External appearance change for the QA conversion adapter module

October 2018

QA6ADP

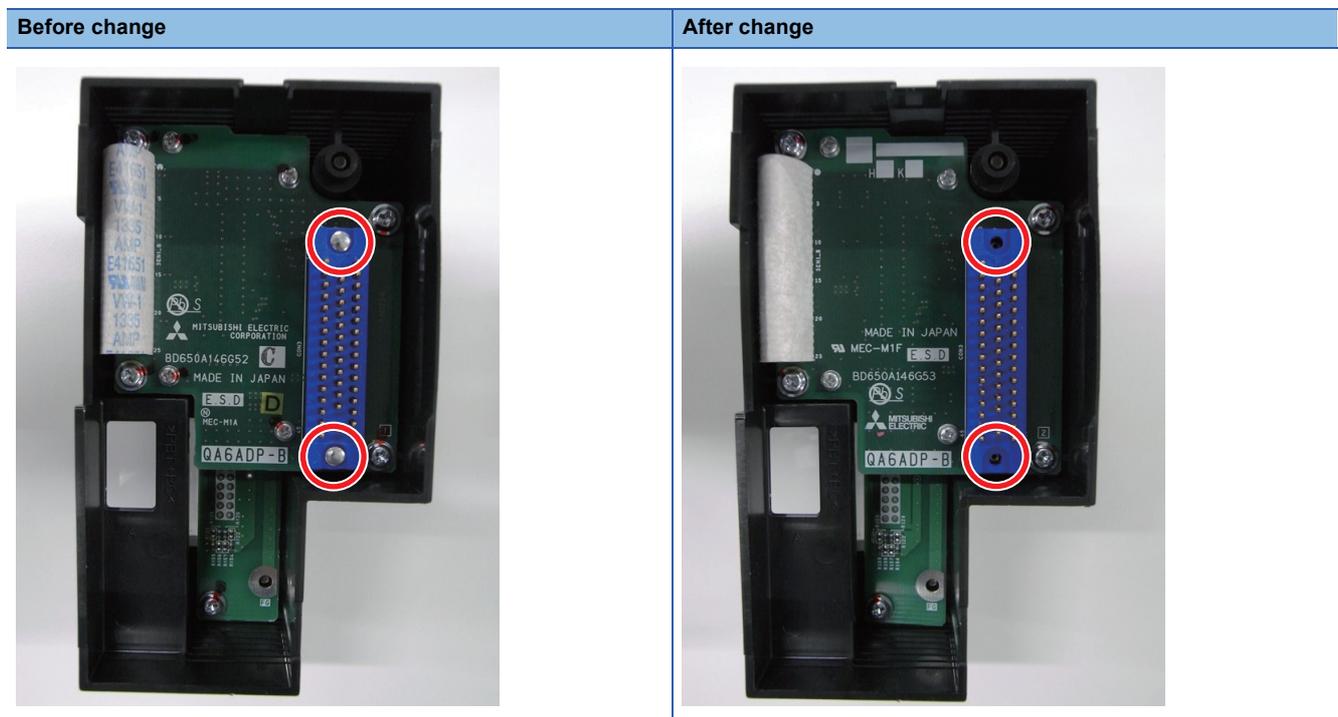
The external appearance of the extension base unit mounting connector will be changed as shown below according to the change of the mounting method to the board.

The extension base unit mounting connector is fixed at the strength equal to that of the conventional product.
